Work Order ID 116468

Item Name: Crosstube Turning Detail

DART AEROSPACE LTD	Work Order: 116468
Description: Crosstube Assembly (205/212/412 High Fwd)	Part Number: D212-664-141
Inspection Dwg: D212-664-141 Rev: D	Page 1 of 2

DRAWING NO. D212-664-141	TITLE XTUBE ASSY (205/212/412 HI FWD)	REV. D	DART AEROSPACE LTD ENGINEERING ORDER		D.E.O. NO. D212-664-141-D-1	SHEET NO. SHEET 1 OF 2	SCALE NTS
DRAWN	CHECKED	MP	MFG. APPR.	RE	APPROVED	MA	DE APPR.
DATE 11.04.07	DATE 11.04.11		DATE 11.04.12		DATE 11/04/12		DATE 11.04.12

**D212-664-141/-141B
ASSEMBLY DETAIL**

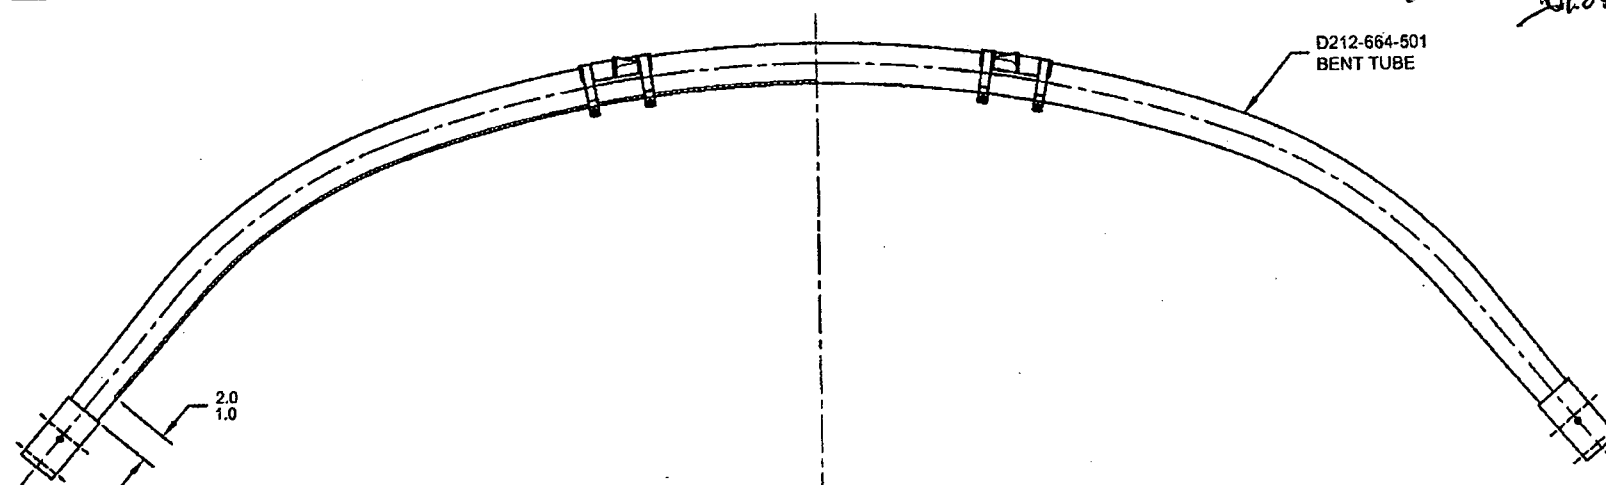
PURPOSE:

ADD AN INSPECTION WINDOW TO UNDERSIDE OF CROSSTUBE.

NOTES 2 OF SHEET 1 IS AMENDED AS FOLLOWS:

- 2) FINISH: CHEMICAL CONVERSION COAT PER DART QSI 005 4.1
PRIME INSIDE AND OUTSIDE PER DART QSI 005 4.2
MASK UNDERSIDE OF CROSSTUBE AS SHOWN (HATCHED AREA) AND
PAINT OUTSIDE PER DART QSI 005 4.2
REMOVE MASKING AND APPLY CLEAR COAT

- 2) FINISH: CHEMICAL CONVERSION COAT PER DART QSI 005 4.1
PRIME INSIDE AND OUTSIDE PER DART QSI 005 4.2
PAINT OUTSIDE PER DART QSI 005 4.2

MASK AREA PRIOR TO PAINTING,
REMOVE MASKING AFTER PAINT
AND APPLY CLEAR COAT
